SUNDRY NOTICES AND REPORTS ON WELLS 6. If Indian, Allottee, or Tribe Name

Jicarilla Apache 127 #115

Re: Permanent Abandonment Well: Jicarilla Apache 127 #115

CONDITIONS OF APPROVAL

Proposed P&A

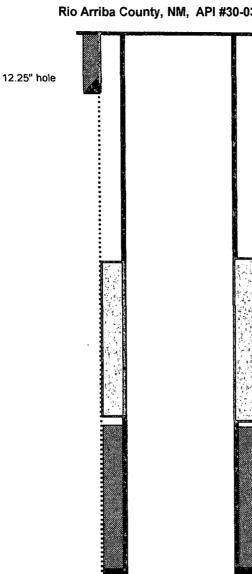
- 1. Plugging operations authorized are subject to the attached "General Requirements for Permanent Abandonment of Wells on Federal and Indian Leases."
- 2. Farmington Office is to be notified at least 24 hours before the plugging operations commence (505) 564-7750.
- 3. The following modifications to your plugging program are to be made:
 - a) Bring the top of plug #2 to 5190 ft. to cover the Mancos top. Adjust cement volume accordingly.
 - b) Bring the top of plug #3 to 3675 ft. to cover the Cliff House and Chacra tops. BLM picks top of Chacra at 37,25 ft. Adjust cement volume accordingly.

Operator will run a CBL to verify cement top. Outside plugs will be required per CBL result. Submit a copy of the log for verification to the following addresses, tsalyers@blm.govBrandon.Powell@state.nm.us
